Sub: Submission of Compliance on Minutes of the 22nd Meeting regarding proposed construction of Chhatrapati Shivaji Maharaj Memorial along with equestrian statue of Chhatrapati Shivaji Maharaj in the Arabian Sea off the coast of Mumbai, Maharashtra; Regarding **Environmental Clearance**.
 (Proposal No. IA/MH/MIS/60961/2015; File No. 11-4/2015-IA-III)

Minutes of 122nd meeting of the Maharashtra Coastal Zone Management Authority held on 30th October, 2017

Item No. 39: Amendment in Proposed Chhatrapati Shivaji Maharaj Meorial in the Arabian Sea at Mumbai by PWD

Figure: Locations for Baseline study of Island Ecology

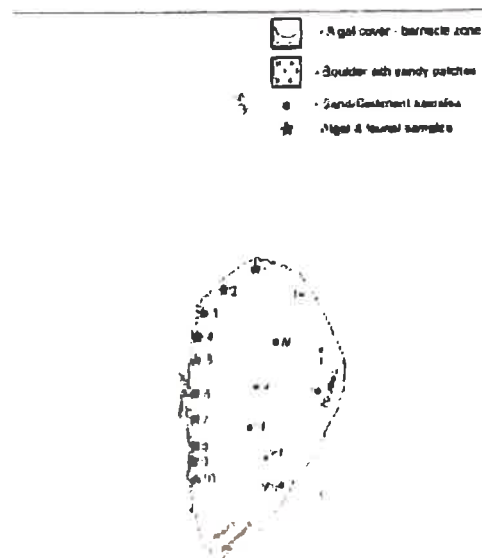
Is reclamation of the Island a part of the project or the Reclaimed Island already exists? Impact on island ecology.

The baseline survey for assessing the sediment texture and phyto-fauna (meio-, macro- and megabenthos) of the island region was conducted at 18 stations during premonsoon season (May, 2014). Out of 18 sampled stations covered for assessing the benthic biodiversity, 8 stations (St. I to St. VIII) were having sandy substratum (Sandy stations) and 10 stations (St. 1 to St. 10) were from macroalgae growing on rocks (Algal stations). Samples for assessment for macrobenthos were collected following the standard methods of collection from intertidal regions. Considering the ecological status of the sessile megabenthic organisms, the occurrence of fauna was only recorded and photographed. The locations of baseline sampling in the island area have been presented in below figure.

A permanent loss of flora and fauna at this rocky outcrop and breakwater zone as a consequence of reclamation is envisaged. The main characteristic of the study site is that it harbours relatively lower diversity of megafauna and macroalgae. However, the study site is found to support few ecologically sensitive species such as Zoanthid (*Zoanthus sansibaricus*), three species of sponges (*Paraleucilla* sp., *Hallichondria panicea*, *Cliona kemp*) and two species of Scleractina corals (*Porites solida*, *Siderastrea savigniana*). Although these species are known to have very wider geographical distributional range in Indo-Pacific region, their distribution at the Rocky outcrop site, however appear to be very patchy. 6 genera belonging to 3 macroalgal groups have been recorded from the study site. Pheophyta was the dominant in terms of wet and dry weight (60% and 56%), followed by Rhodophyta (39% and 43%) whereas the Chlorophyta showed very low composition (1% and 0.43%). Chlorophyta was less abundant in the study area compared to the other intertidal rocky areas of Maharashtra. This could be because the study area remains submerged for most of the time and gets fully exposed only during the neap tide. Careful planning and execution of various construction activities could minimize the impact on flora and fauna. An increase in turbidity due to enhanced levels of Suspended solids can negatively influence the photosynthesis and hence the primary productivity. However, the impact, if any would be local, temporary and reversible with the phytoplankton community structure quickly reestablishing once the construction is completed. A temporary and minor reduction in phytoplankton standing stock as a result of marginal increment in turbidity is unlikely to produce any negative impact on zooplankton standing stock. However, marginal localized change in the community structure and population alternations may occur confined to the project area. Such changes are temporary and negligible considering the good primary and secondary productivity potentials of the study region.
